This Addendum forms part of the Bid Documents and amends the Bid Documents as described below.

END OF ARCHITECTURAL ADDENDUM NO. 2

Project: Kedron East Catholic Elementary School

This Addendum forms part of the Contract Documents and amends the original Drawings, Specifications, Schedules and Details.

3/E3 WALL MOUNTED MODULAR CLASSROOM CONTROL PANEL
SCALE: N.T.S.

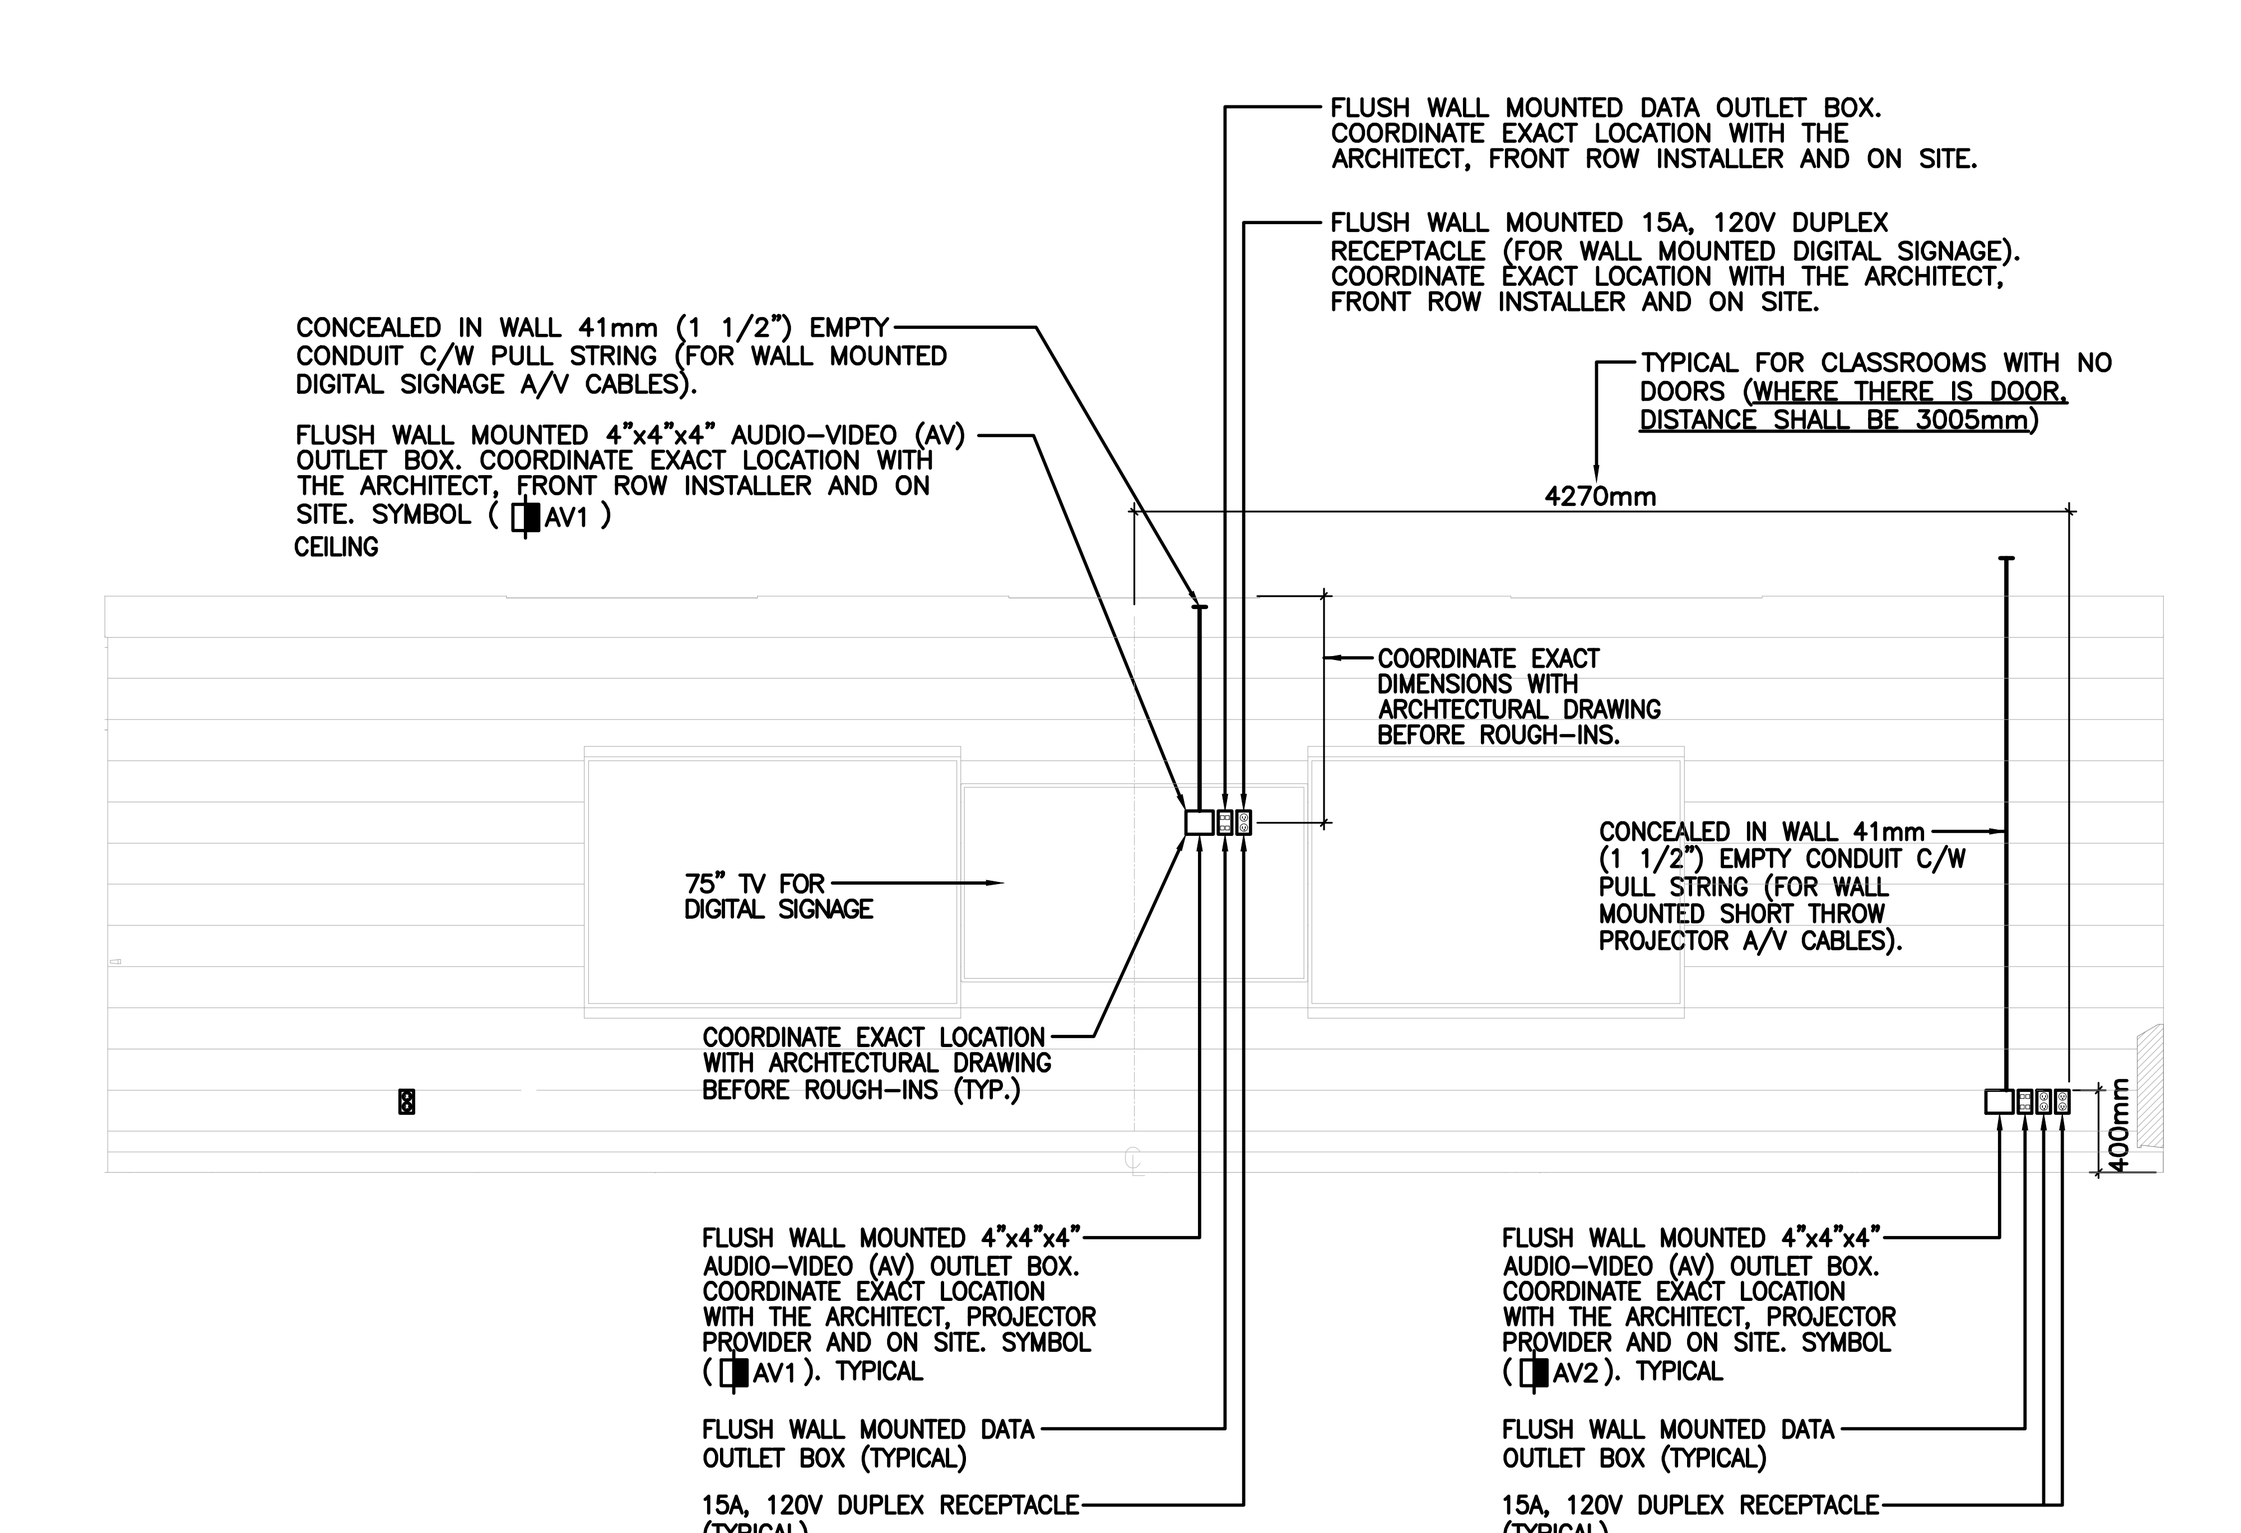
1.1 Different system symbols are added and revised in certain areas as shown in attached revised drawing.
1.2 Detail #3/E3 is revised as shown in attached revised drawing.

3 HUB ROOM No.116
E5 SCALE: 1:50

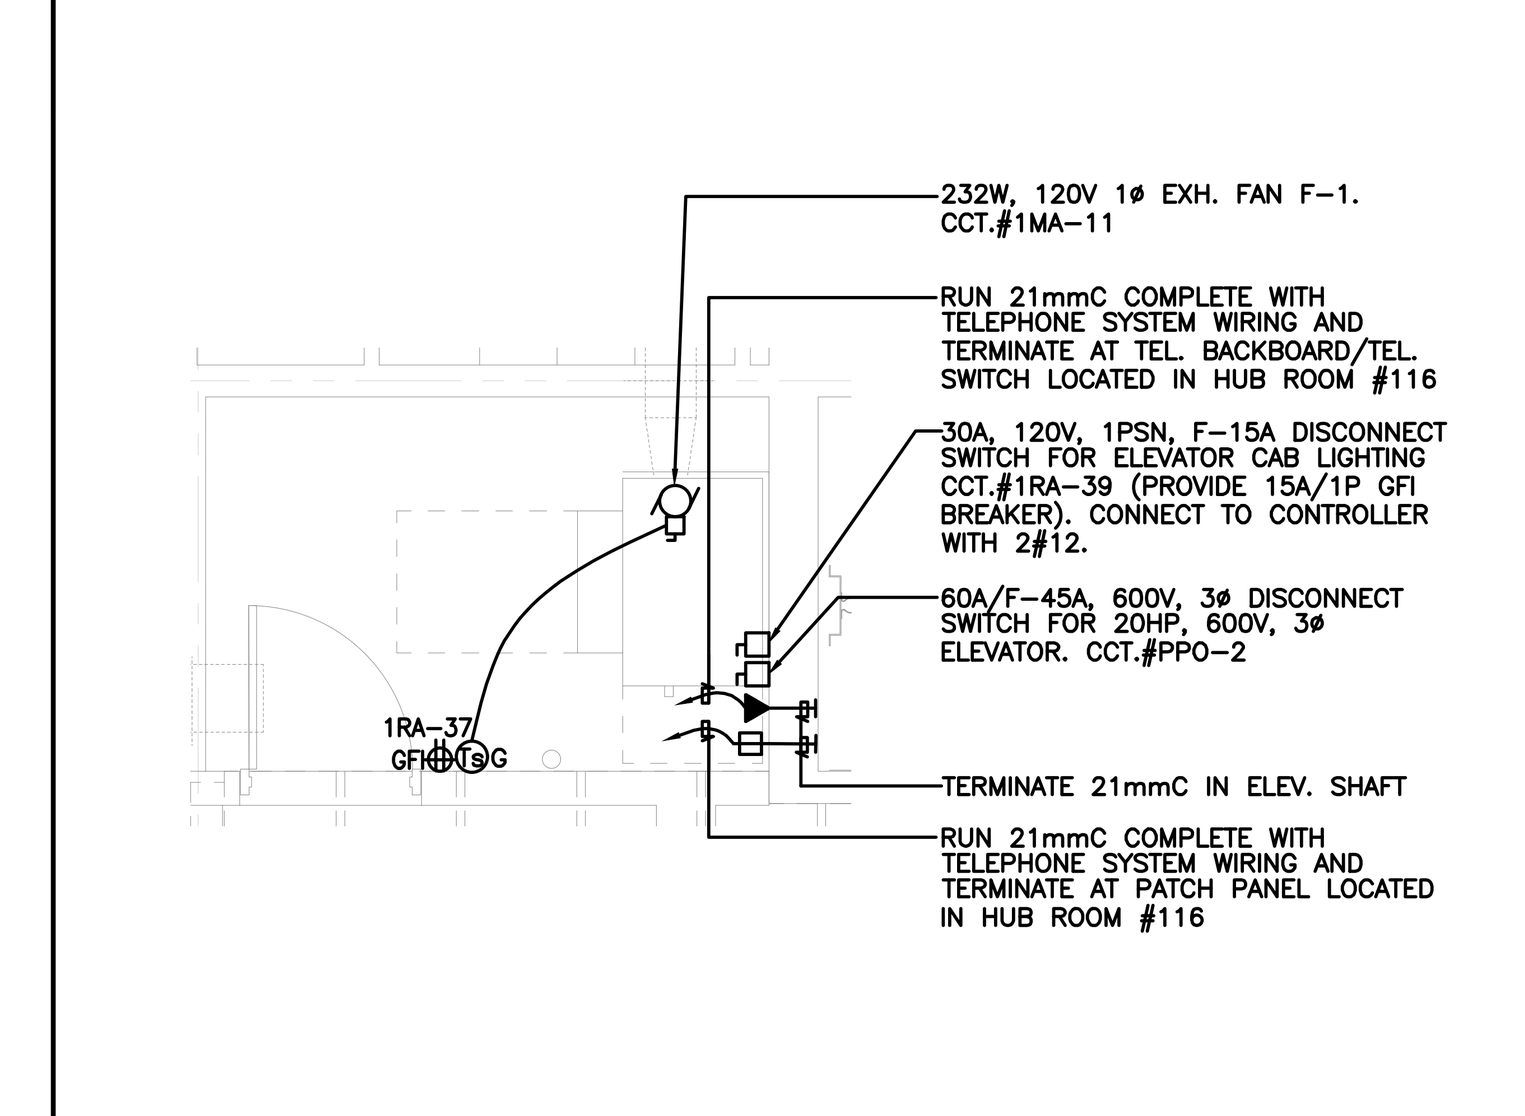
3.1 Device types are revised at classroom control panels and in certain areas as shown on attached revised drawings.
3.2 Hub room #116 equipment revised to new requirement as shown on attached revised drawing.
